AGENDA

PLANNING & ZONING COMMISSION REGULAR MEETING TUESDAY, FEBRUARY 21, 2023 - 3:30 PM MCALLEN CITY HALL, 1300 HOUSTON AVENUE CITY COMMISSION CHAMBERS, 3RD FLOOR

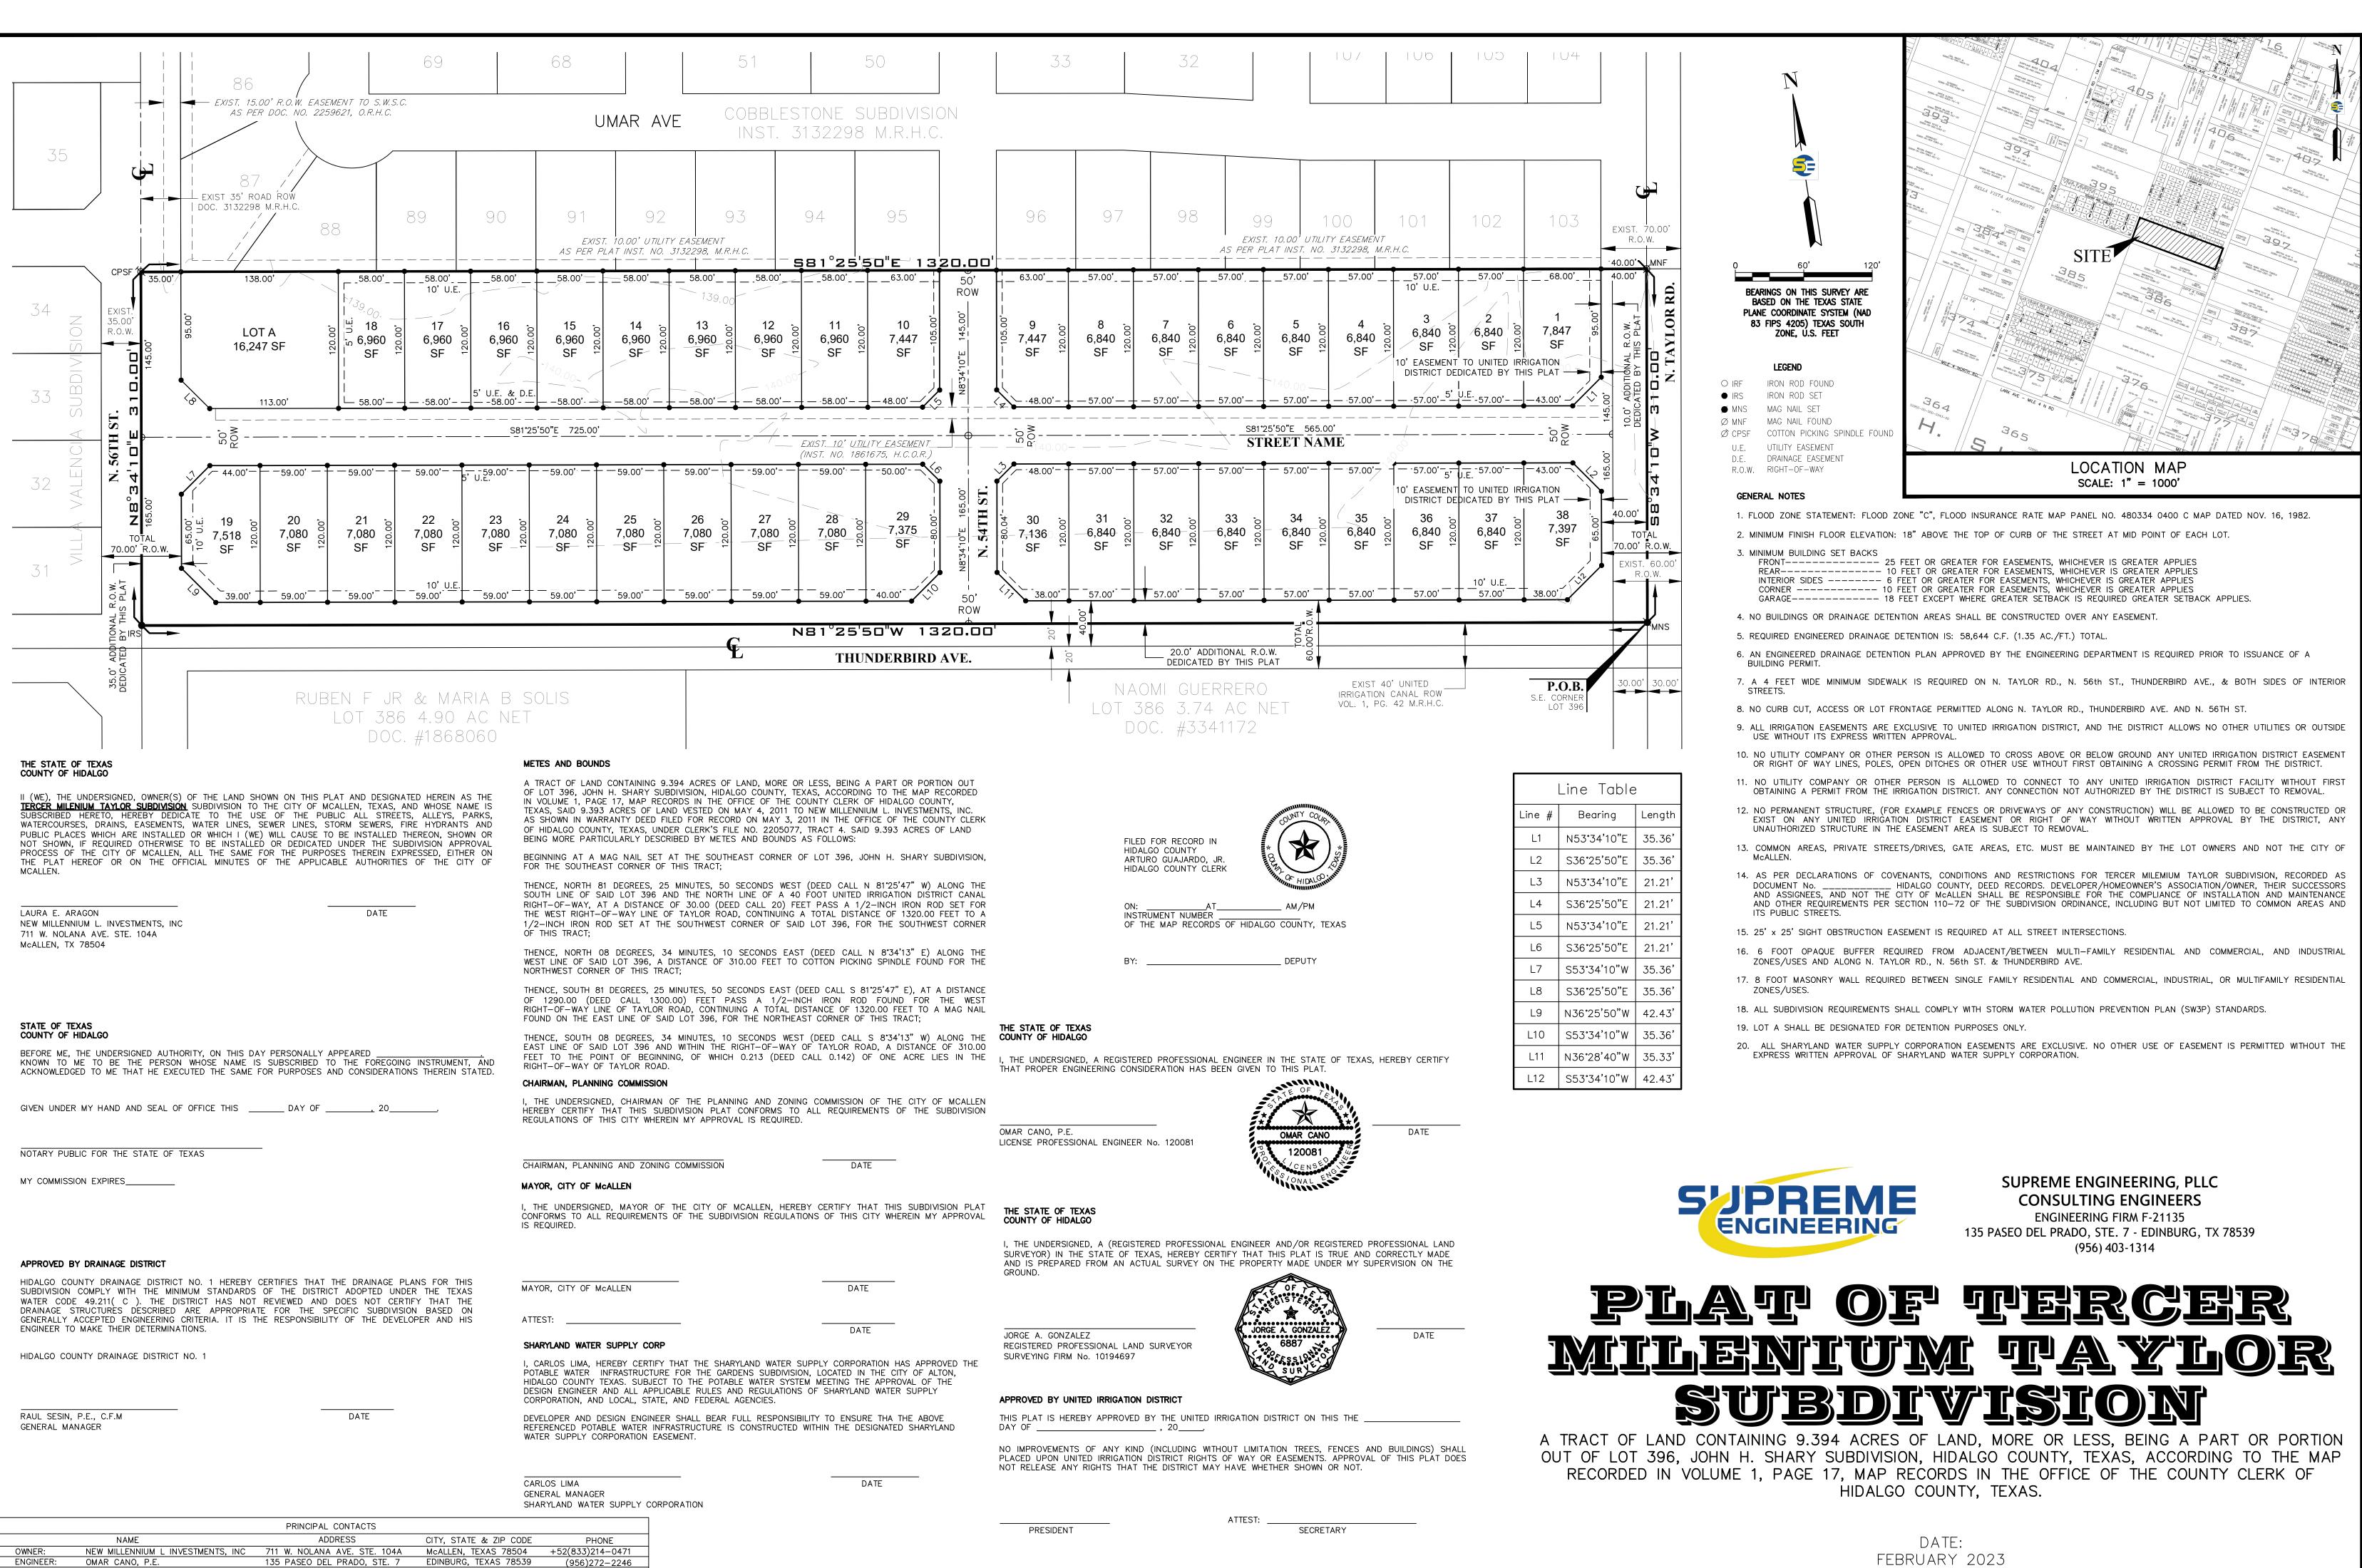
SUBDIVISION NAME: TERCER MILENIUM TAYLOR		
REQUIREMENTS		
STREETS AND RIGHT-OF-WAYS		
N. Taylor Rd Minimum 10 ft. dedication for 40 ft. from Centerline for 80 ft. ROW Paving: 52 ft. Curb & gutter: Both Sides **Subdivision Ordinance: Section 134-105 ***Monies must be escrowed if improvements are not built prior to recording. ****COM Thoroughfare Plan	Applied

N. 56th St 35 ft. dedication from centerline for 70 ft. ROW Paving: 44 ft. Curb & gutter: Both sides **Subdivision Ordinance: Section 134-105 ***Monies must be escrowed if improvements are not built prior to recording. ****COM Thoroughfare Plan	Applied	
Thunderbird Ave Dedication for 40 ft. from centerline for 80 ft. ROW Paving: 52 ft. Curb & gutter: Both sides *City's thoroughfare map calls Thunderbird Avenue for an 80 ft. ROW, therefore, additional 20 ft. dedication for 40 from centerline required. As per plat submitted 7/19/22, 10 ft. additional ROW is being dedicated instead of the 20 ft. ROW required. As per plat submitted on August 12,2022 and December 5th,2022 20 ft. of additional ROW dedicated by this plat. **Subdivision Ordinance: Section 134-105 ***Monies must be escrowed if improvements are not built prior to recording. ****COM Thoroughfare Plan	Applied

N. 54th St 50 ft. ROW Paving: 32 ft. Curb & gutter: Both sides **Subdivision Ordinance: Section 134-105 ***Monies must be escrowed if improvements are not built prior to recording. ****COM Thoroughfare Plan	Applied	
E/W Interior Street - 50 ft. ROW Paving: 32 ft. Curb & gutter: Both sides *Street name will be finalized prior to final. **Subdivision Ordinance: Section 134-105 ***Monies must be escrowed if improvements are not built prior to recording. ****COM Thoroughfare Plan	Applied

* Site plan must be approved by the Planning and Development Departments prior to building permit issuance.	NA
* Common Areas, any private streets/drives, gate areas, etc. must be maintained by the lot owners and not the City of McAllen. **Revise Note#13 as applicable, as per conversation with Engineer on October 3rd,2022, subdivision proposed to be a Public Subdivision, prior to recording.	Required

* Homeowner's Association Covenants must be recorded and submitted with document number on the plat, prior to recording. **Homeowner's Association Covenants must be submitted for staff review, prior to recording. ***Section 134-168 applies if private subdivision is proposed. ****Section 110-72 applies if public subdivision is proposed. *****As per conversation with Engineer on October 3rd,2022, subdivision proposed to be a Public Subdivision, revise notes as applicable. ******Landscaping Ordinance: Section 110-72 ******Subdivision Ordinance: Section 134-168 	Required
LOT REQUIREMENTS
